PLANNING COMMISSION REPORT Public Hearing Item

FINAL DEVELOPMENT PLAN FOR BAUER FARM MULTI-DWELLING; NORTHWEST NORTH OF W 6TH STREET/HWY 40 WEST OF THE INTERSECTION WITH FOLKS ROAD (MKM)

FDP-15-00066: Consider a Final Development Plan for Bauer Farm-Multi-Family, a 100 unit multi-dwelling residential development containing approximately 4.0 acres, located at 4700 Overland Drive. Submitted by Treanor Architects, for Bauer Farms Residential LLC, property owner of record.

Figure 3. Areas which have been developed and those which have approved Final Development Plans. The area in gray is the recently approved Sprouts Grocery Store which is currently under construction. Subject property is outlined.

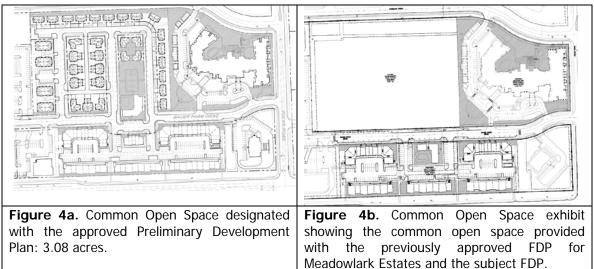
Several Development Plans have been approved for both the commercial and residential portions of the development. Figure 3 shows the areas with approved development plans, the developed area, and the subject property. The area in gray is the Sprouts Grocery Store and

out lots recently approved with FDP-14-00207. Properties have been platted as development has been proposed. As the subject property is not yet platted, the approval of the Final Development Plan is contingent upon the recording of a final plat. A final plat has been submitted and is also on the June Planning Commission agenda for consideration.

SITE LAYOUT PLAN

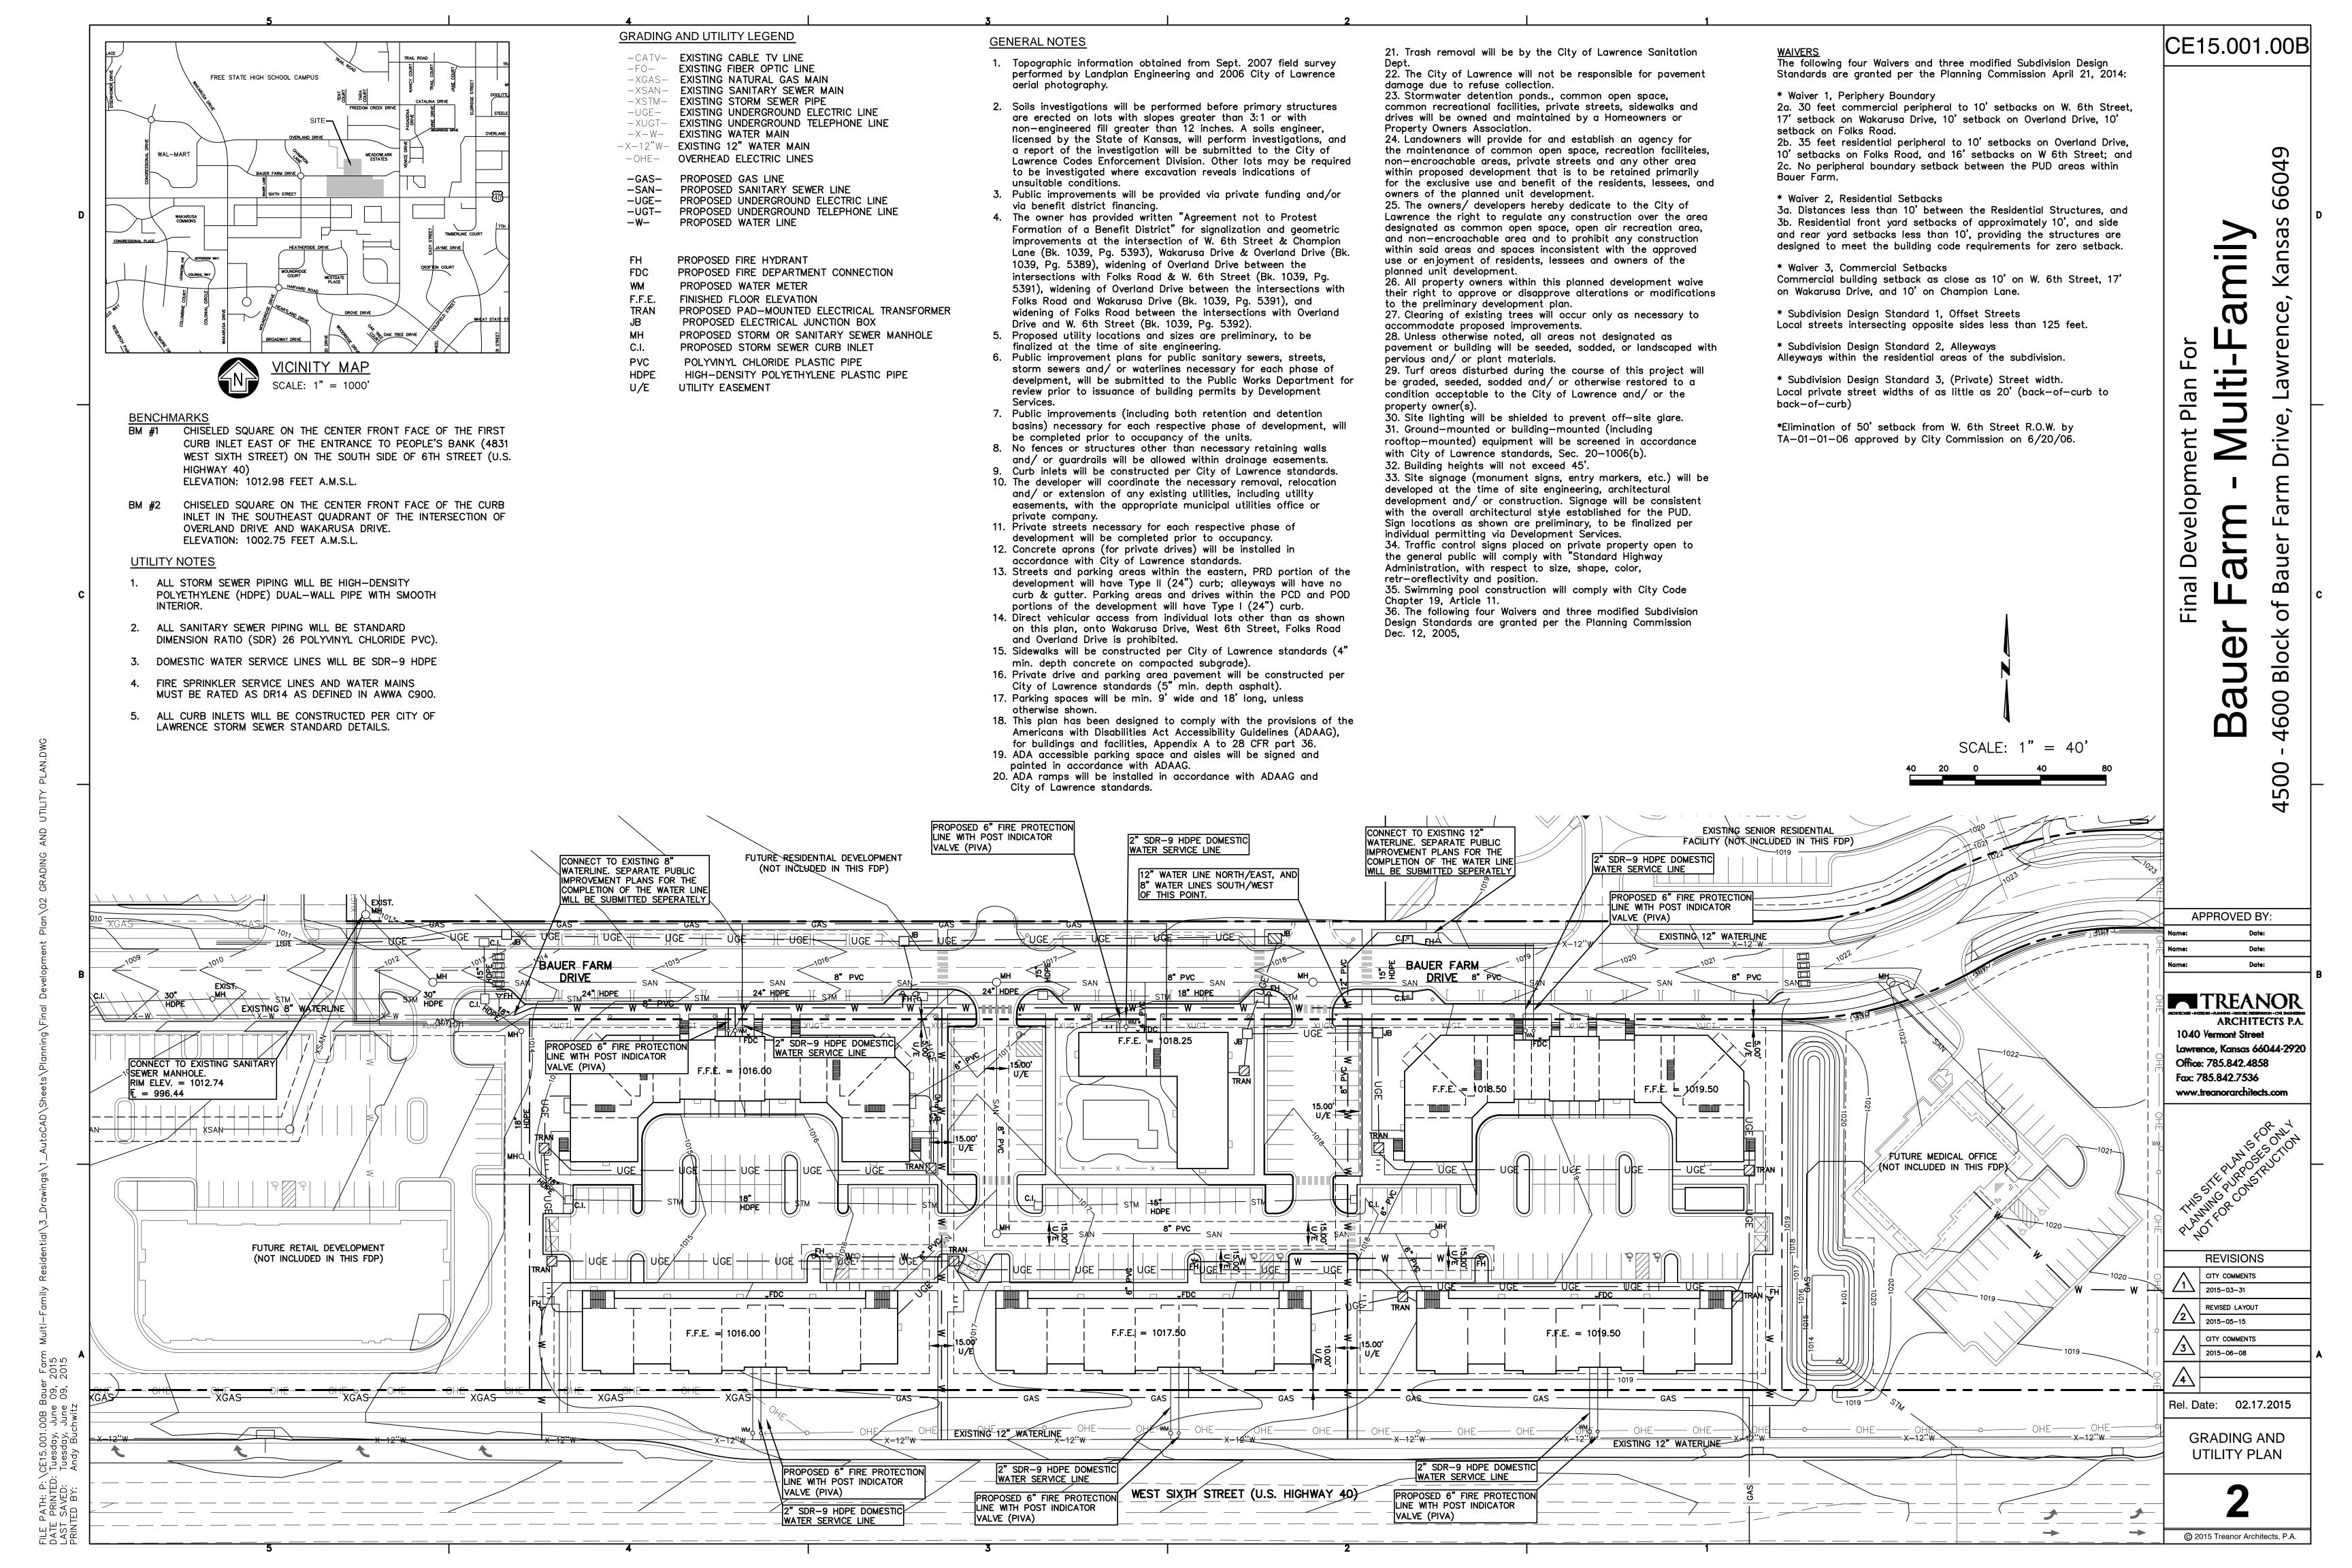
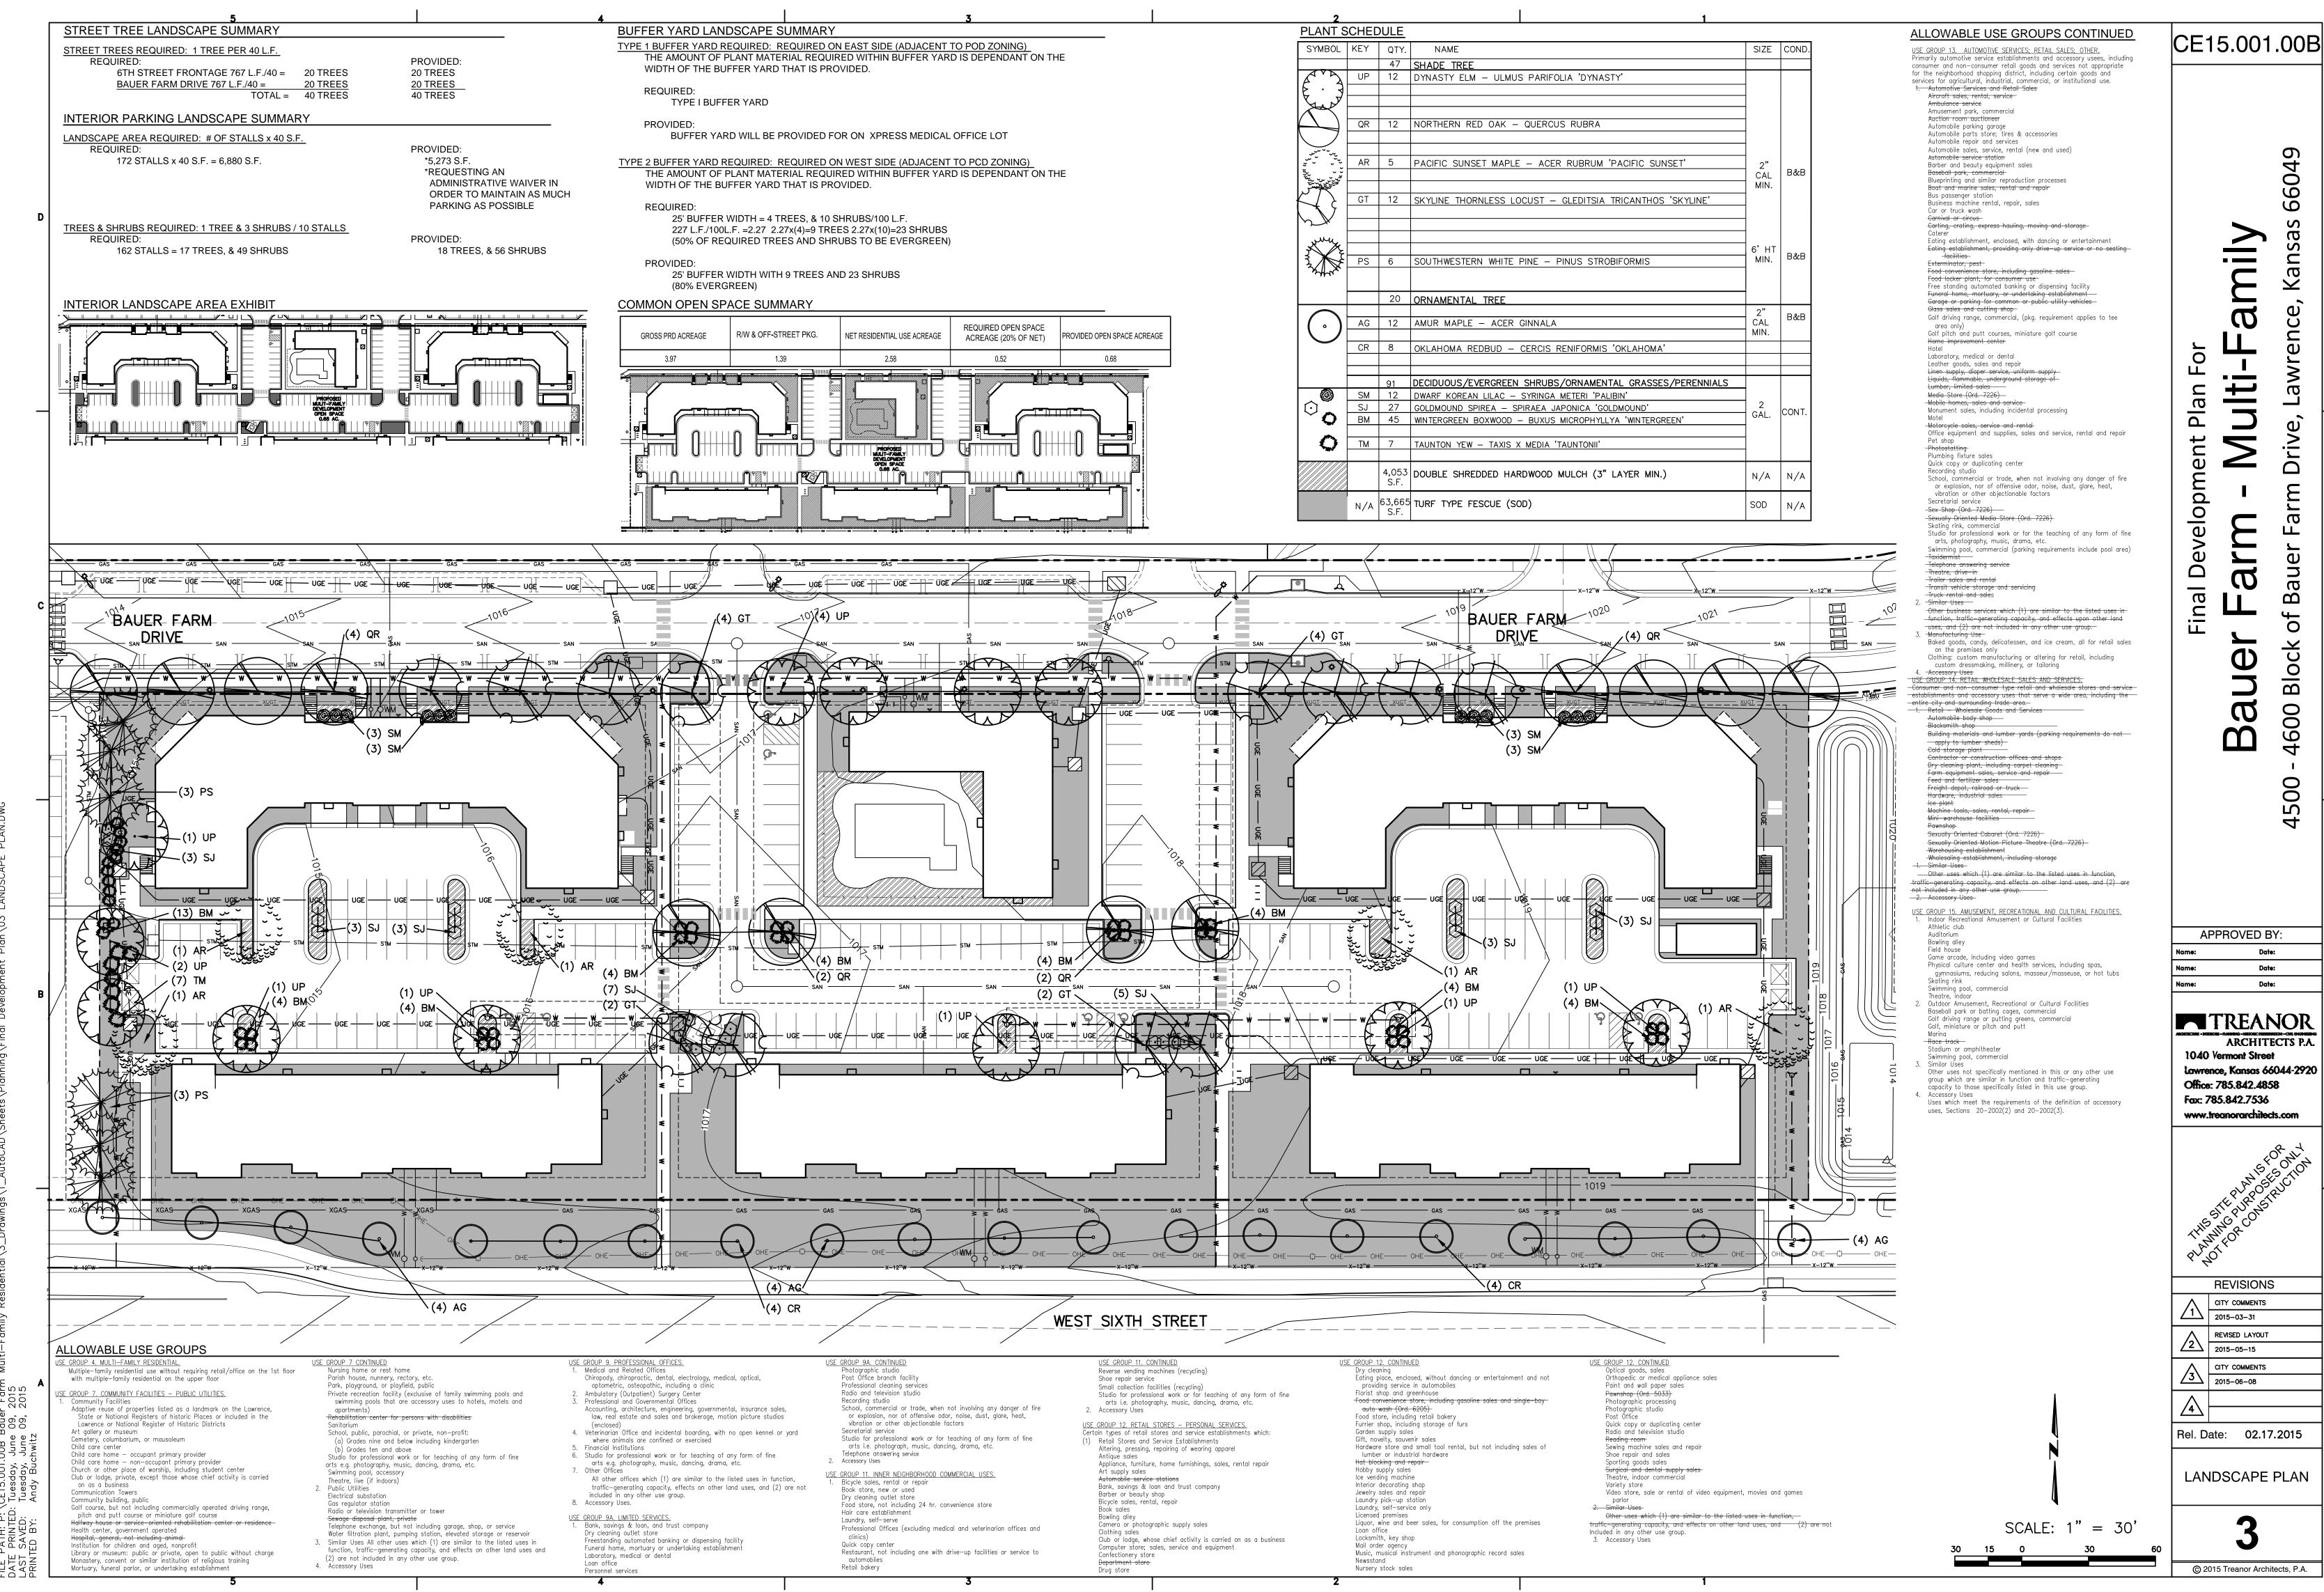
The items on the Final Development Plan which vary from the approved Preliminary Development Plan include the following:

- 1) Reconfiguration of Bauer Farm Drive, extended.
- 2) Reduction in number of dwelling units from 150 to 100.
- 3) Relocation and reduction of the Common Open Space. (The remainder of the required Common Open Space will be provided on the development to the north.)

Two access points on Bauer Farm Drive, extended, will provide access to the apartment parking areas. Bauer Farm Drive is proposed to run straight from Folks Road to Champion Road without the jog that had been shown in the approved Preliminary Development Plan. Speed humps will be installed on the west portion of Bauer Farm Drive to control traffic.

PHOTOMETRIC SITE PLAN

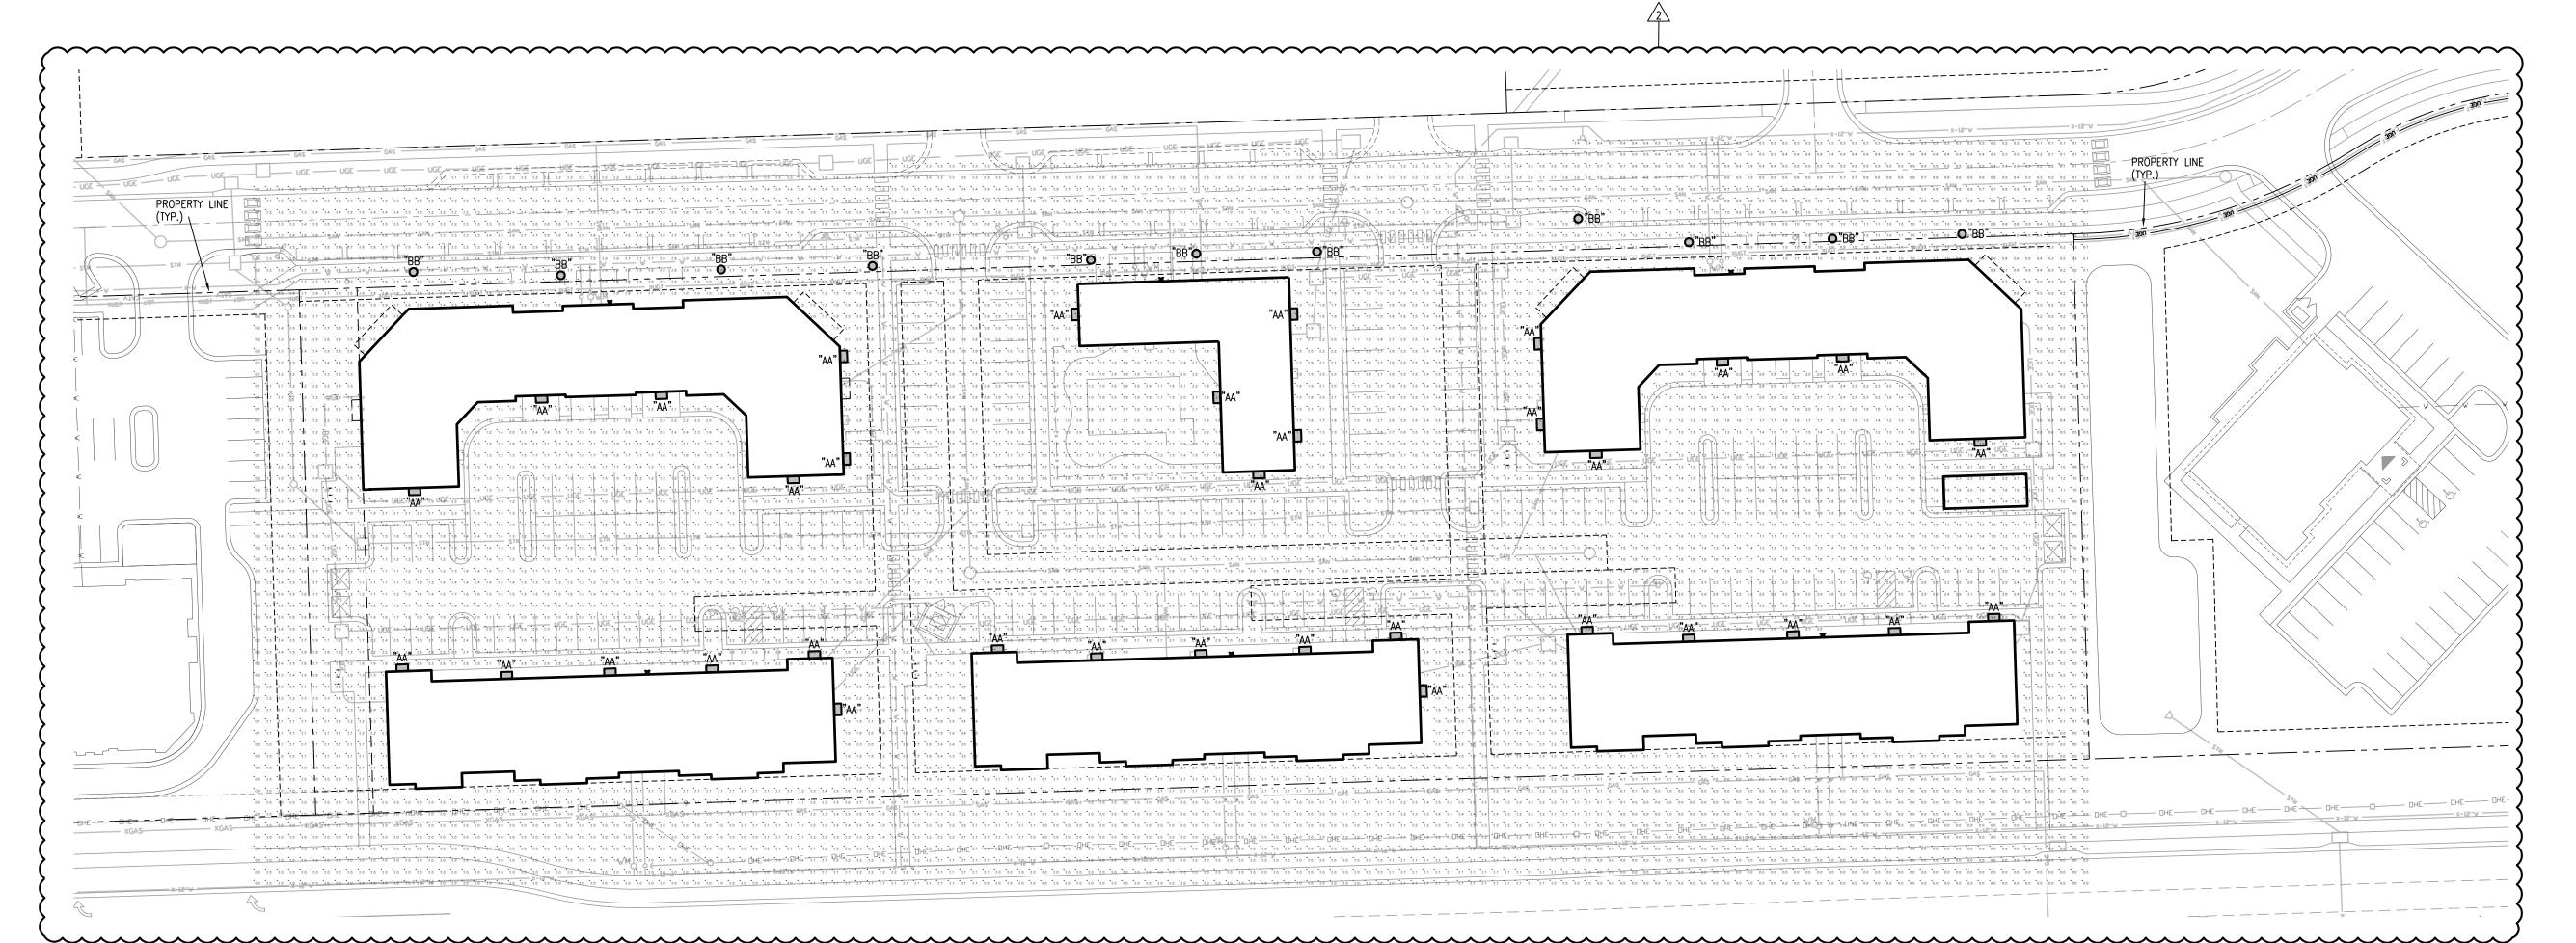
A point by point illumination array was provided for the parking lot lighting being proposed with this development. The lighting levels were compliant with the standards in Section 20-1103(d)(3) with the exception of the lighting levels along Bauer Farm Drive. A revised photometric plan should be provided and approved prior to release of the plan for building permits. The lighting will include pedestrian scale street lighting as previously approved along Bauer Farm Drive through the development.

- 1. A revised photometric plan shall be provided and approved prior to release of the plan for building permits.
- 2. The final plat for the subject property, Bauer Farm Seventh Plat, shall be recorded with the Register of Deeds, prior to the recordation or release of the Final Development Plan.
- 3. Provision of a revised Maintenance Agreement reflecting the revised development for recording with the Register of Deeds.
- 4. Provision of a revised plan with minor changes per Fire Code Officials approval.
